**CITY PLAN COMMISSION****THURSDAY, MAY 4, 2023****FILE NUMBER:** S223-126**CHIEF PLANNER:** Mohammad H. Bordbar**LOCATION:** Mockingbird Lane, west of Oak Brook Boulevard**DATE FILED:** April 7, 2023**ZONING:** MU-3**CITY COUNCIL DISTRICT:** 2    **SIZE OF REQUEST:** 1.56-acres**MAPSCO:** 33V**APPLICANT/OWNER:** PNXY limited Partnership

**REQUEST:** An application to create one 0.73-acre lot and one 0.83-acre lot from a 1.56-acre tract of land in City Block D/7937 on property located on Mockingbird Lane, west of Oak Brook Boulevard.

**STAFF RECOMMENDATION:** The request complies with the requirements of the MU-3 Mixed Use District; therefore, staff recommends approval of the request subject to compliance with the following conditions:

**FINAL PLAT**  
**PVNY MOCKINGBIRD ADDITION**  
LOTS 1 & 2, CITY BLOCK D/7937  
BEING A 68.147 SQ. FT., 1.56 ACRE TRACT OF LAND  
SITUATED IN THE CU CHANDLER SURVEY,  
ABSTRACT NO. 356  
CITY OF DALLAS, DALLAS COUNTY, TEXAS  
CITY PLAT FILE NO.: 5223-126  
ENGINEERING PLAN NO.:

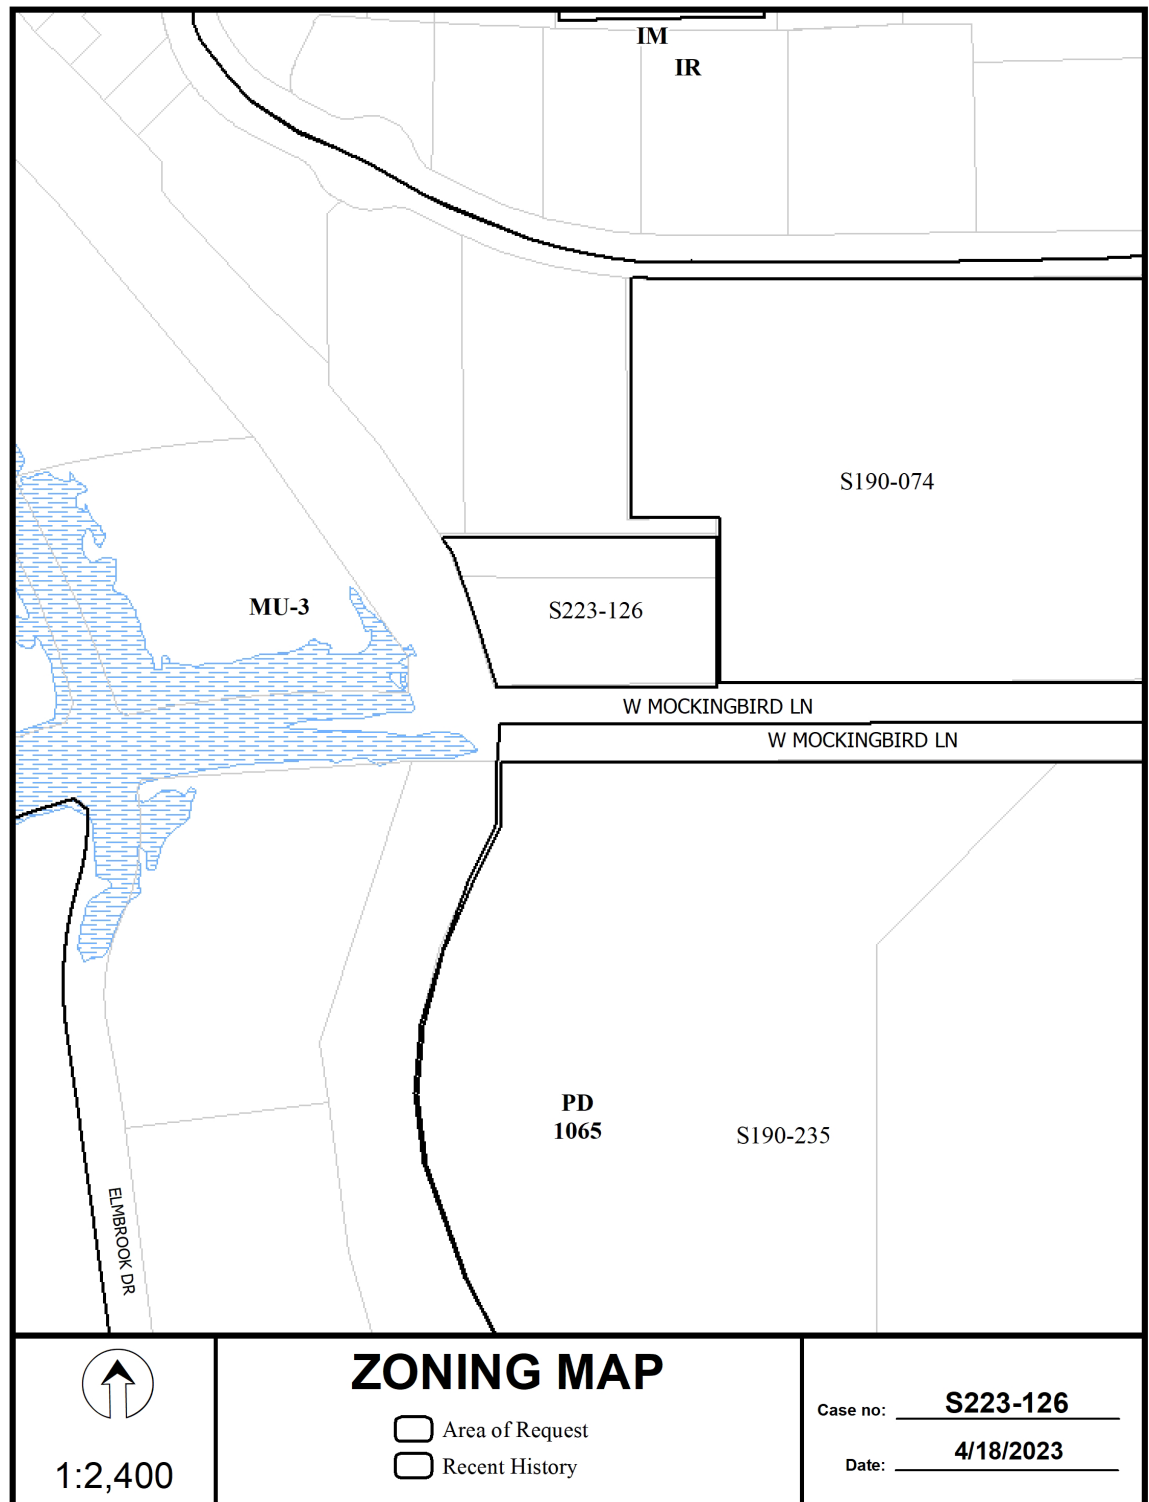
23. Prior to final plat, submit a completed final plat checklist and all supporting documents.

24. Additional design information is required for assessment. Site plan must be submitted showing proposed development, building finished floor elevation, development, existing mains – including downstream manhole, and proposed water and wastewater service locations. Submit water/wastewater engineering plans to 320 E. Jefferson Blvd., Room 200, Attention: Water and Wastewater Engineering.
25. Existing and any proposed Water and Wastewater Easements must be shown and/or increased to conform to current design standards. **Notice:** Minimum DWU easement size 20' for one utility and 25' for both water and sewer. Larger diameter or deeper mains may require additional width.

26. On the final plat, change “W. Mockingbird Lane” to “Mockingbird Lane”. Section 51A-8.403(a)(1)(A)(xii)
27. On the final plat, identify the property as Lot 7 and Lot 8 in City Block D/7937. Ordinance 1A, Page 131 pages 131-148, Section 2 (passed August 13, 1872).
